# HONDA Service Bulletin

March 23, 2004 Applies To: 2002-04 Odyssey - ALL

# Clunk From the Rear Brakes

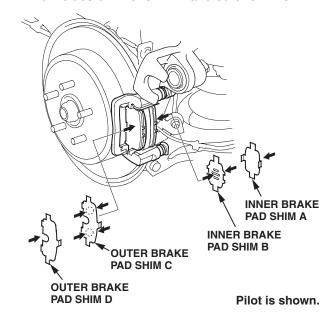
The outer shims on the rear brake pads do not allow the pads to slide easily when you press the brake pedal. This causes the outer pad to hit hard during a change of direction, resulting in a clunk.

Replace the rear brake pad shims.

- 2. Apply a thin coat of M-77 assembly paste to the new brake pad shims in these areas:
  - The back of inner shim A and outer shim D.
  - Both sides of inner shim B and outer shim C.

3. Install the new brake pad shims (four per side) on each rear caliper. For Pilots, refer to the 2003-04 Pilot Service Manual, page 19-19. For Odysseys, refer to the 1999-04 Odyssey Service Manual, page 19-26.
